Project Owner:	Shelby Public Schools
Project Name:	New Elementary Technology Systems
Issue Date:	November 14, 2022

PROJECT QUESTIONS AND ANSWERS

*This document provides answers to questions asked by bidders who have reviewed the **Technology Request for Bid** for the above referenced project.*

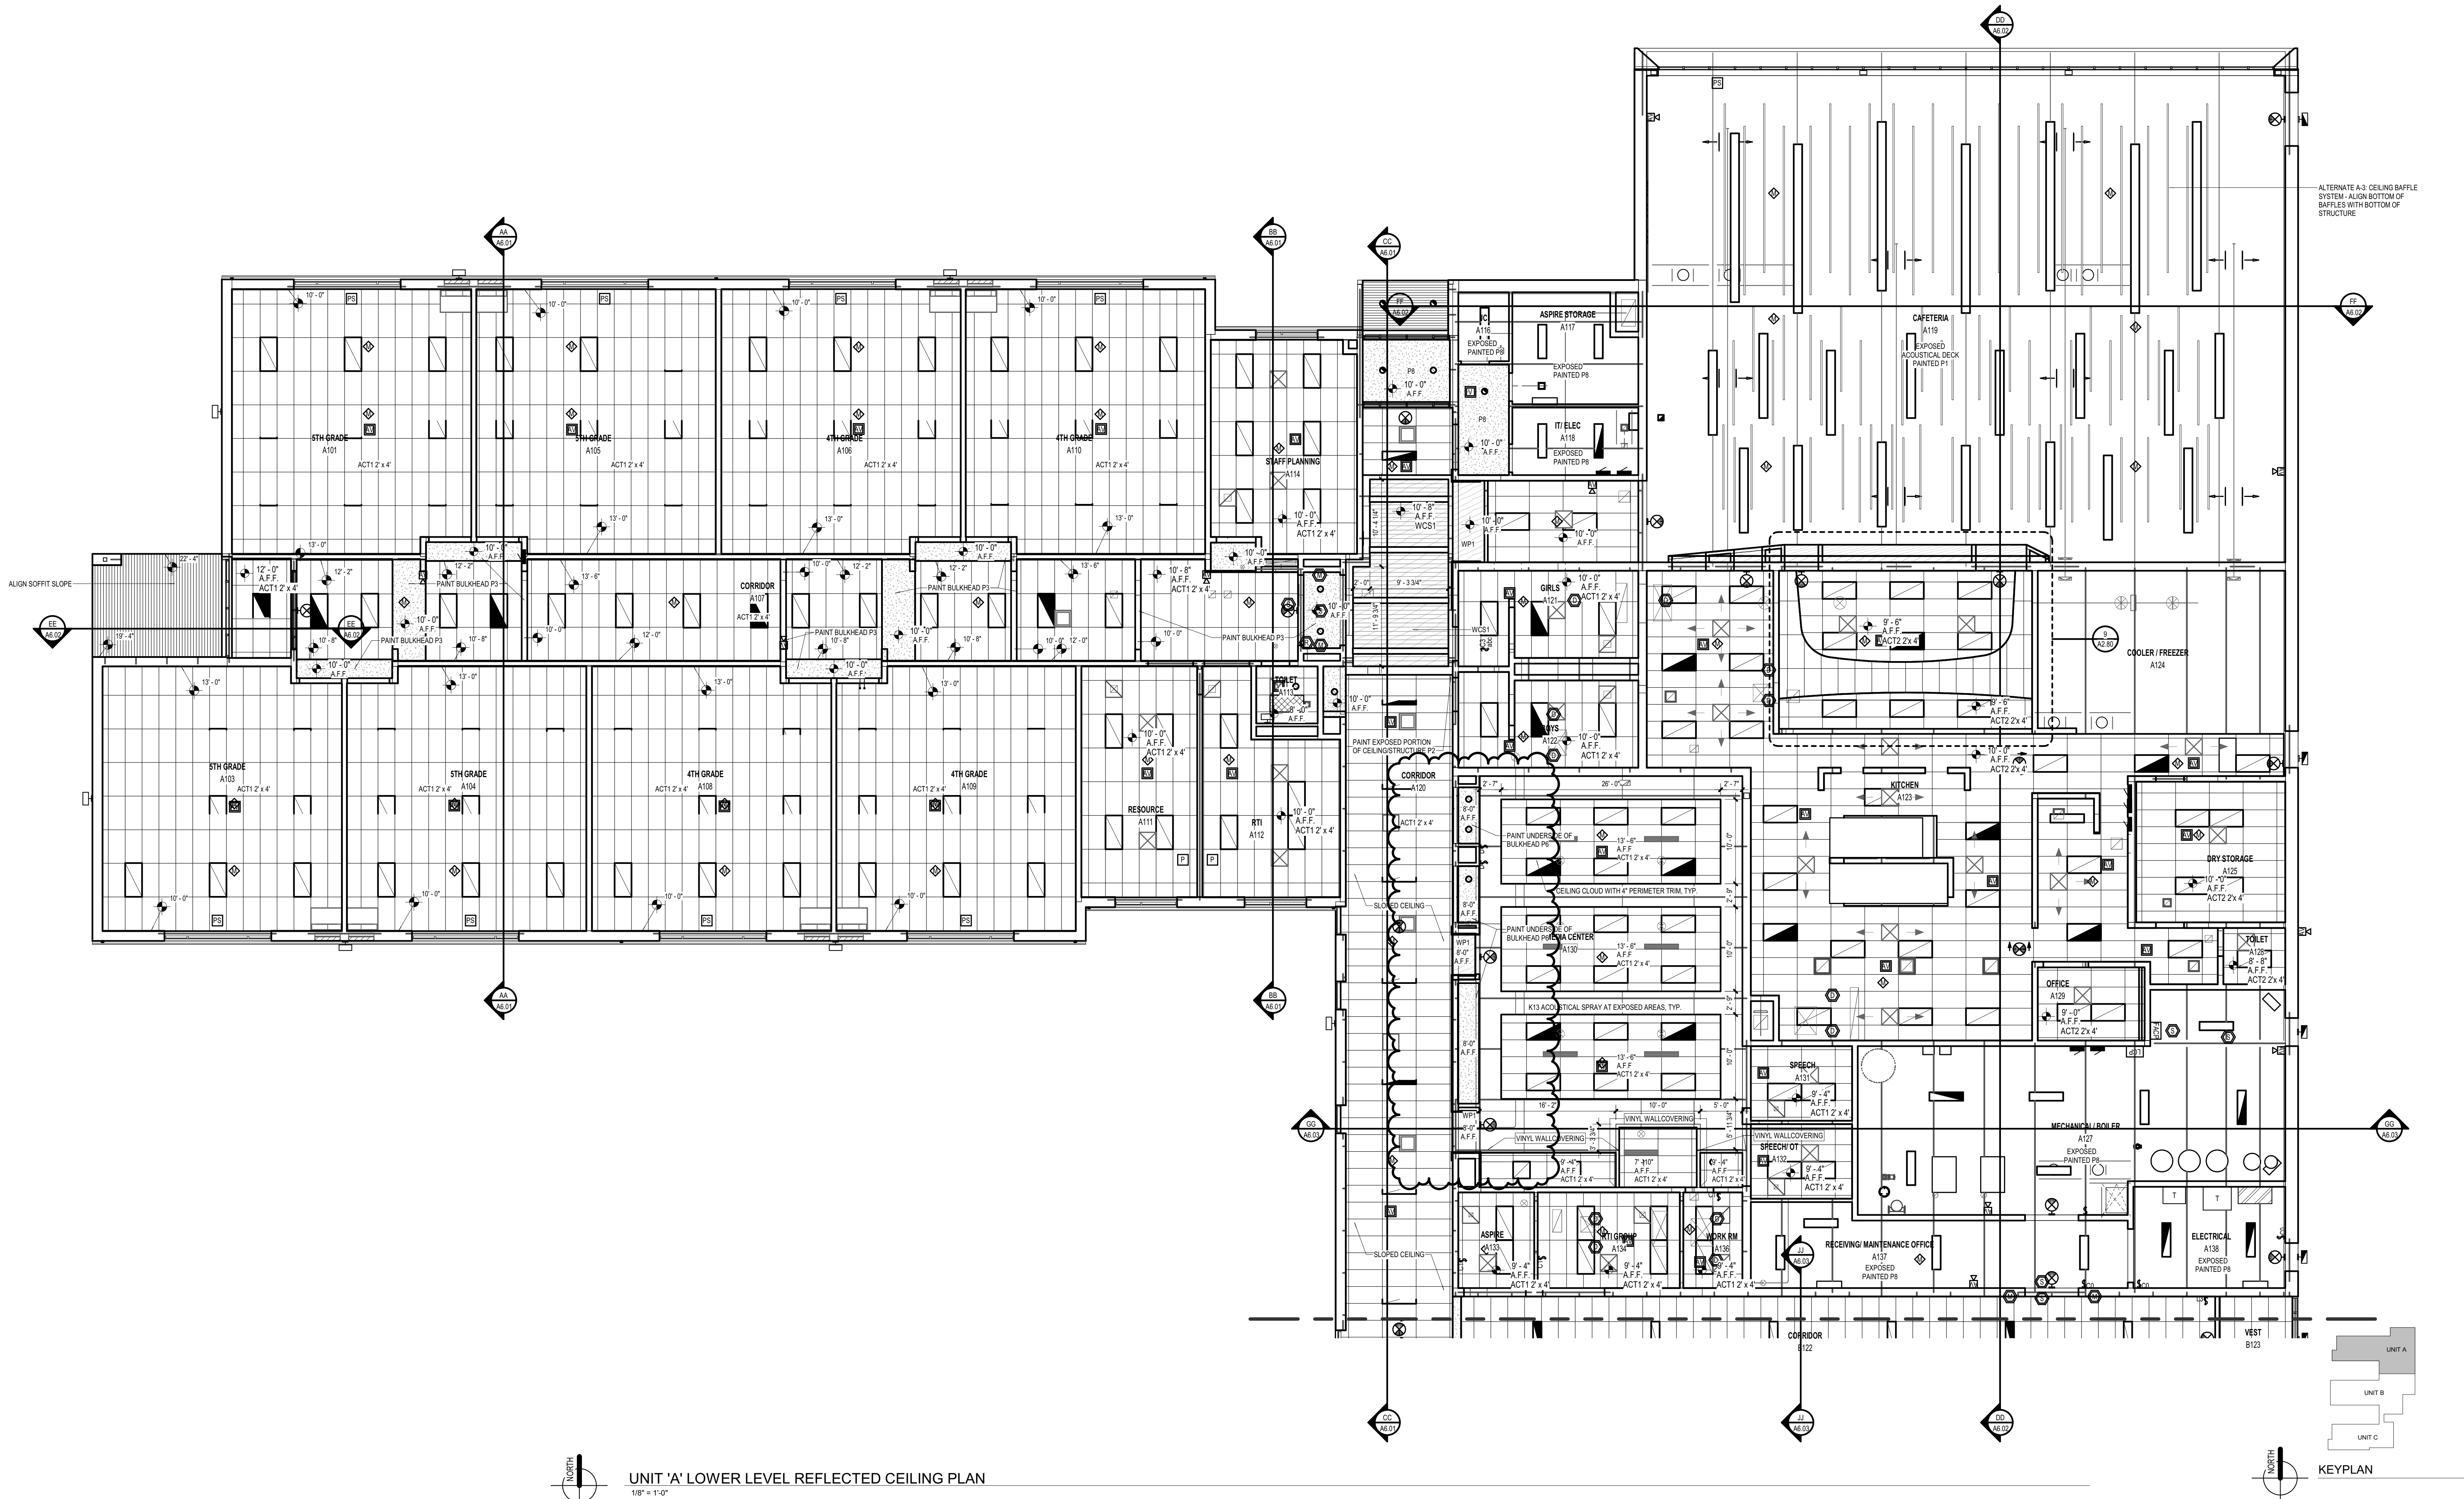
Q13: The access control credentials state 13.56MHz and the card readers are 125kHz. Do you want kHz credentials or multi-class readers?

A. Multi-class readers. HID multiCLASS SE RP15 (Mullion Style) and HID multiClass SE RP40 (Wall Switch Style).

UNIT 'B' MIDDLE LEVEL REFLECTED CEILING PLAN
1/8" = 1'-0"

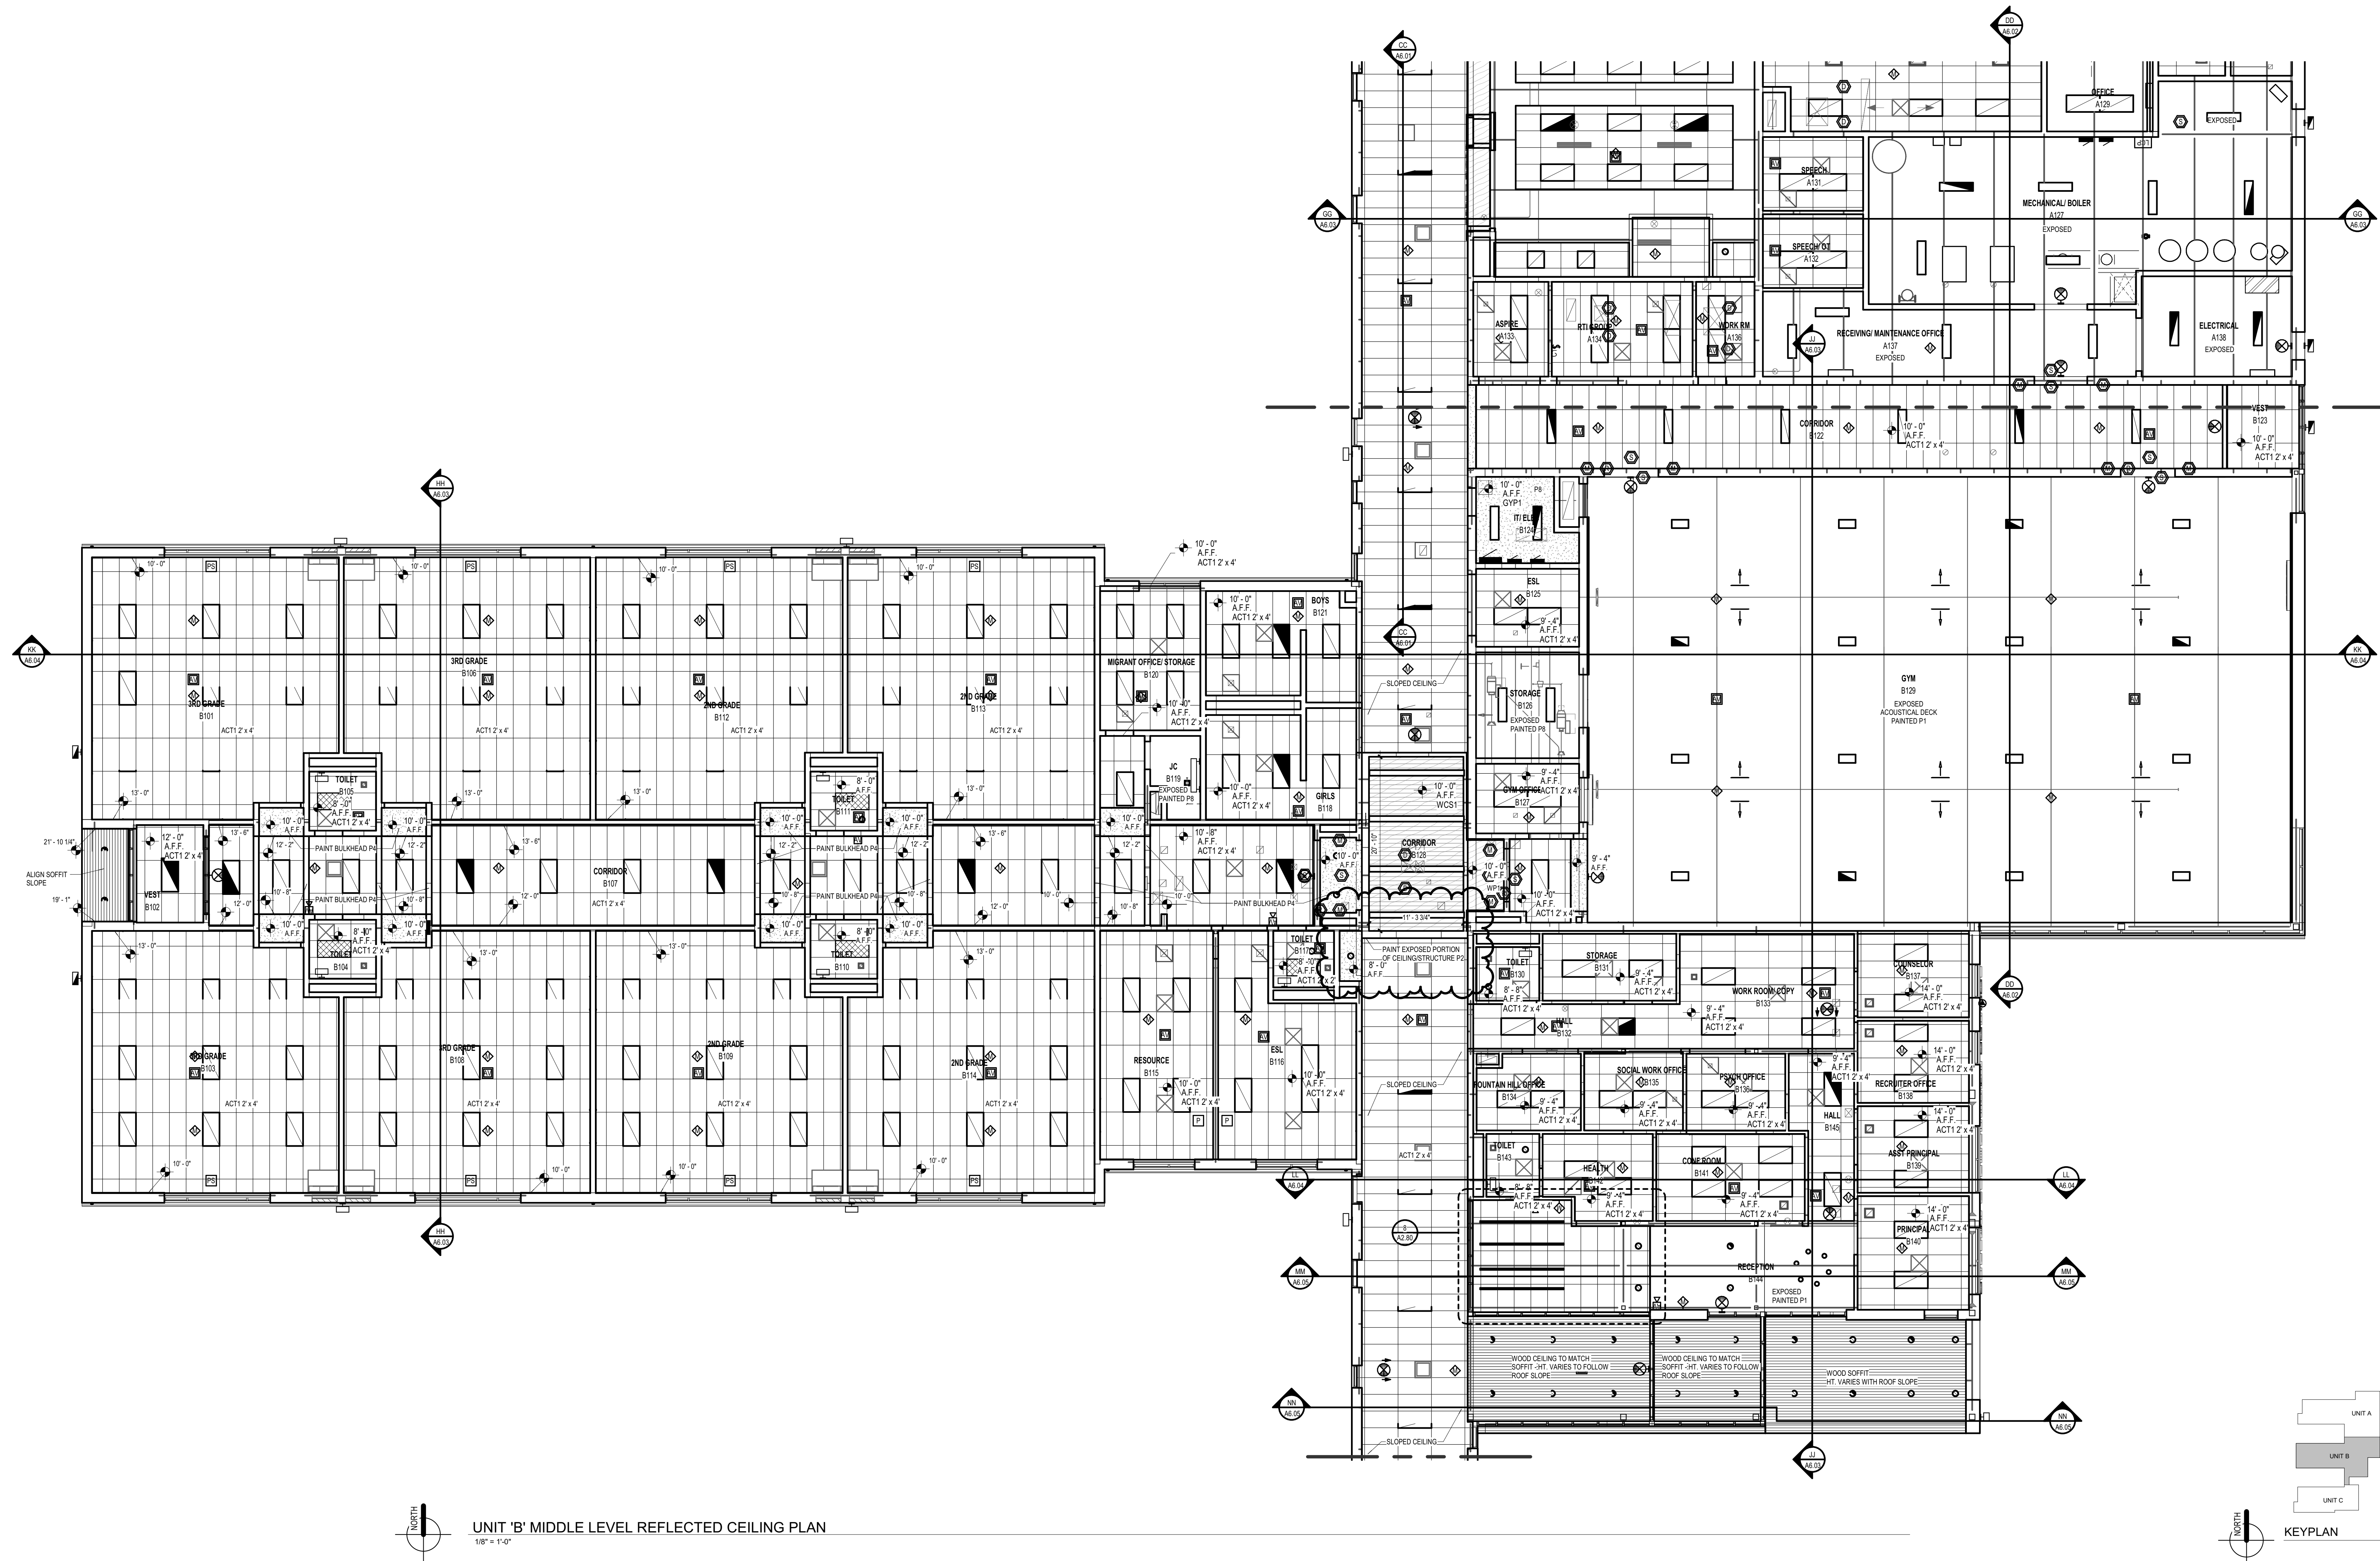
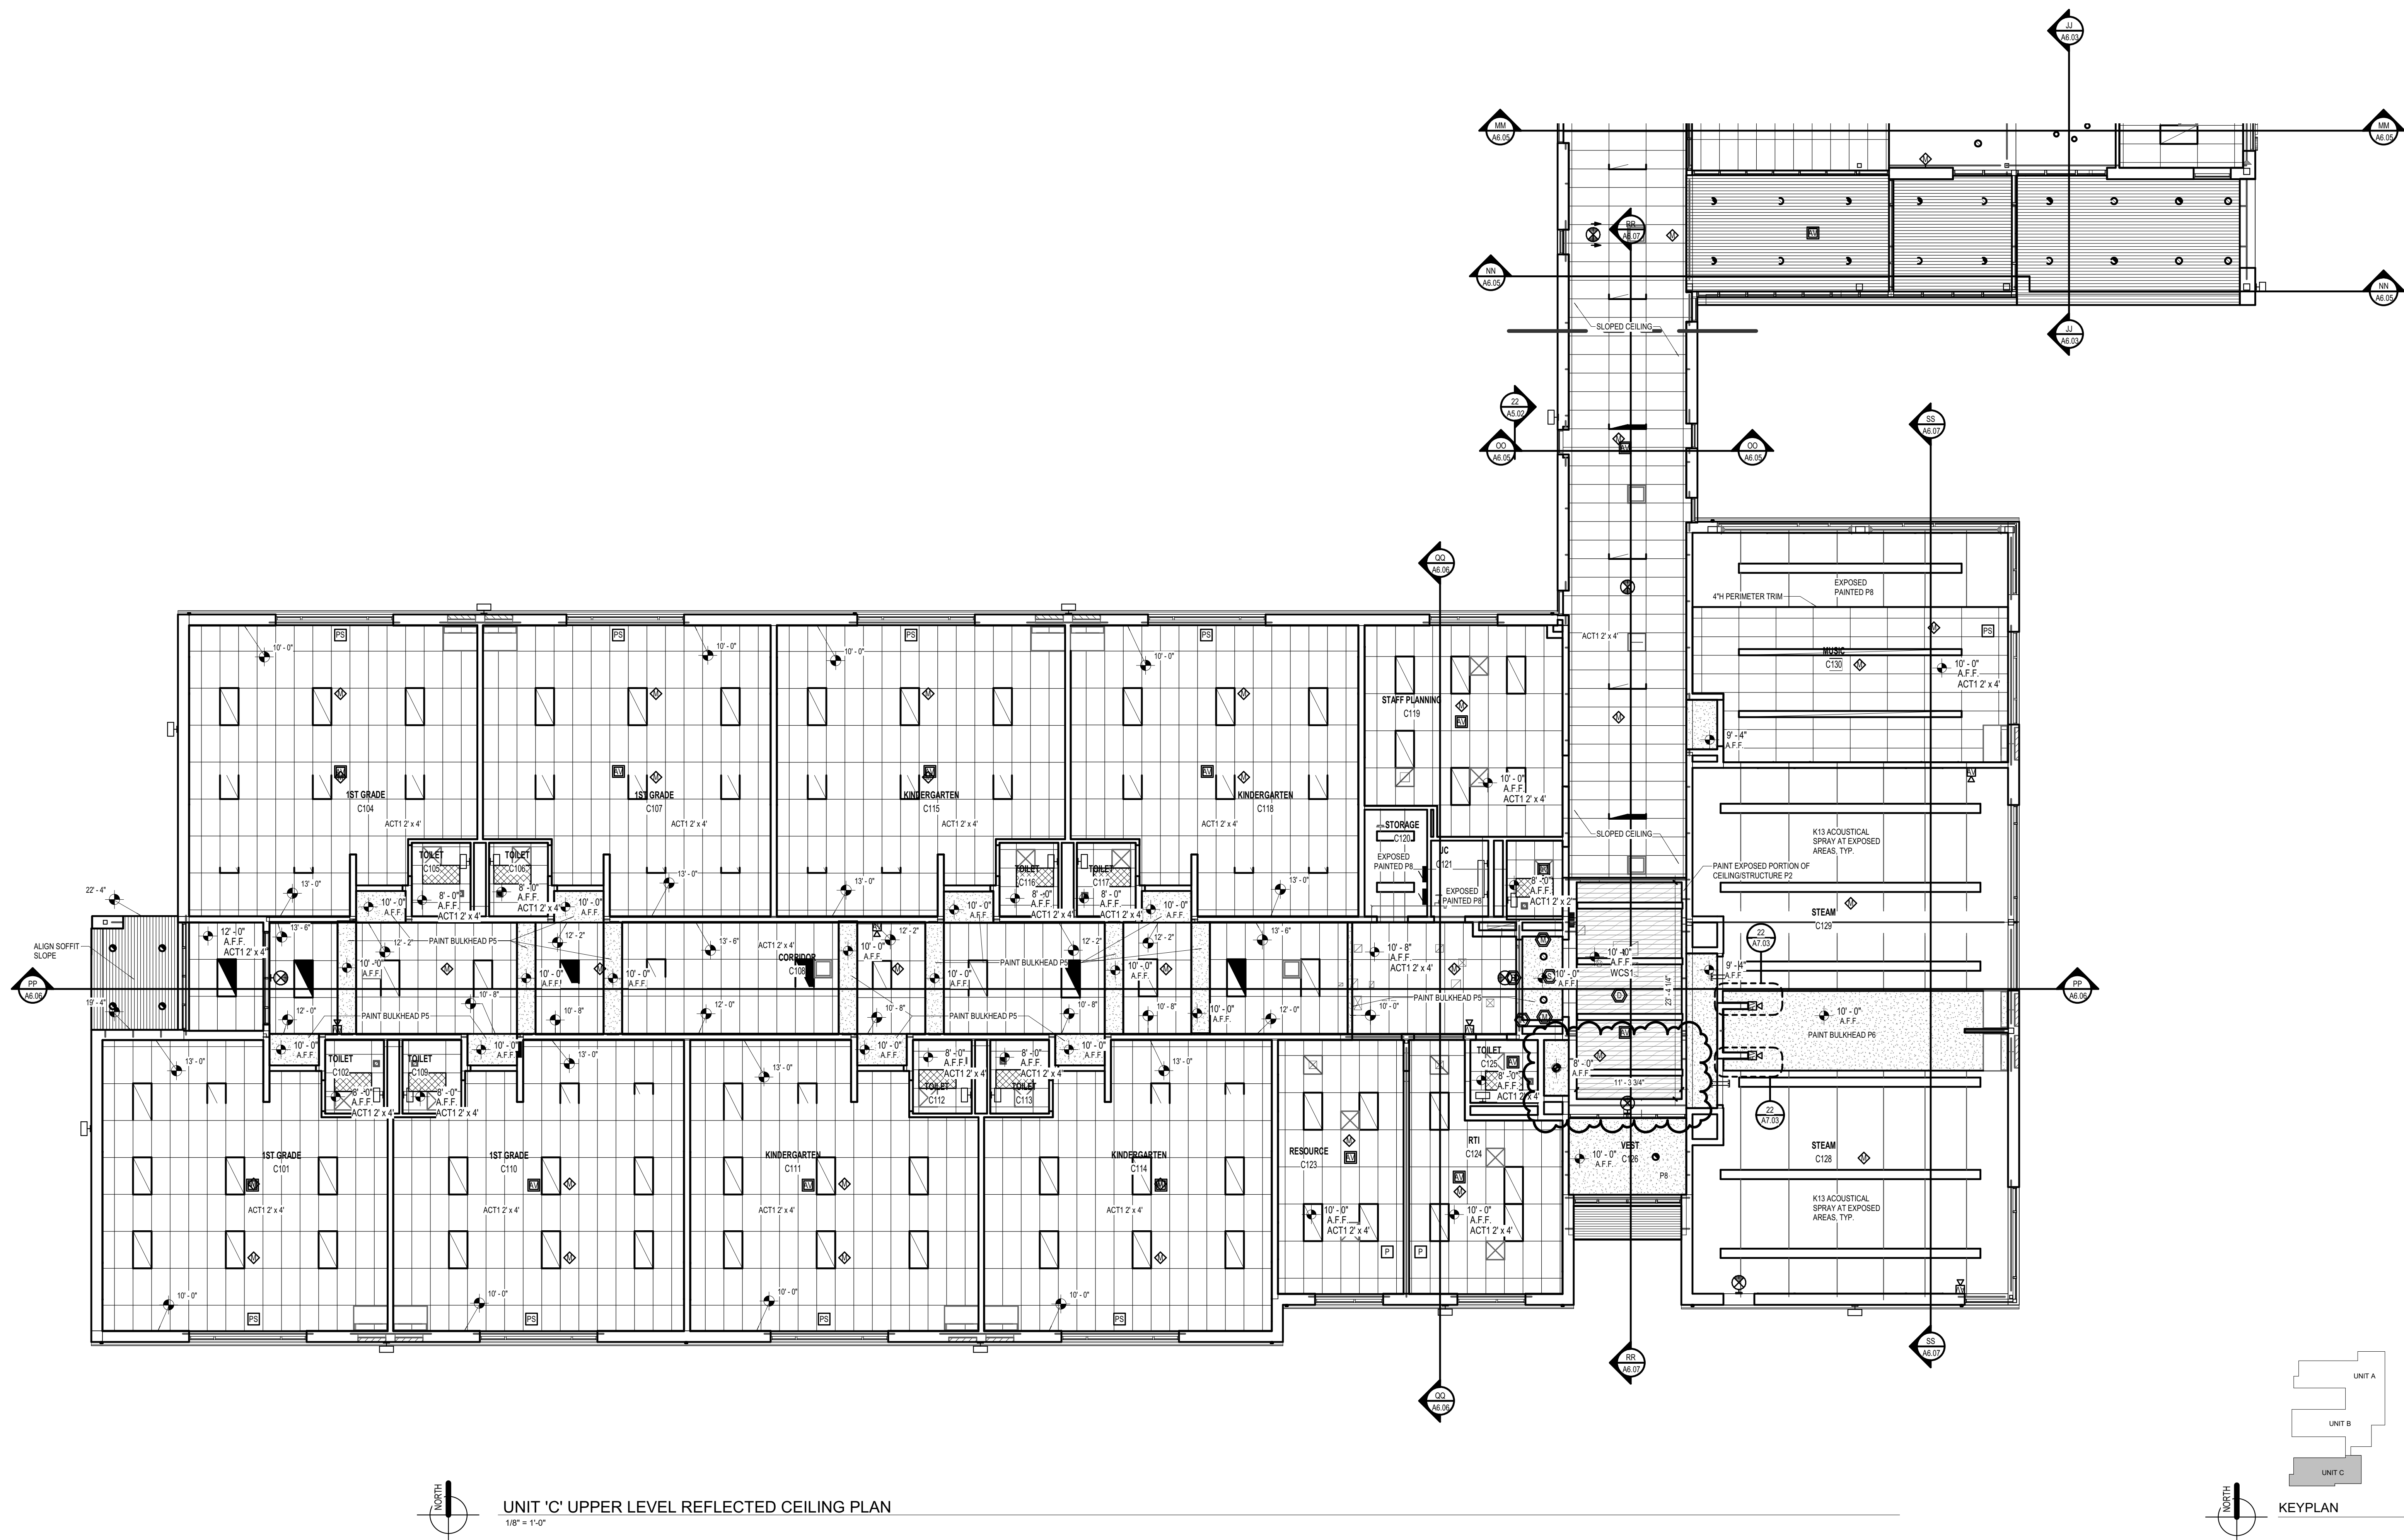
Q11: Are the ceilings all lift out drop in tile? Ceiling height?

A: See the attached drawings: Reflected Ceiling Plan.
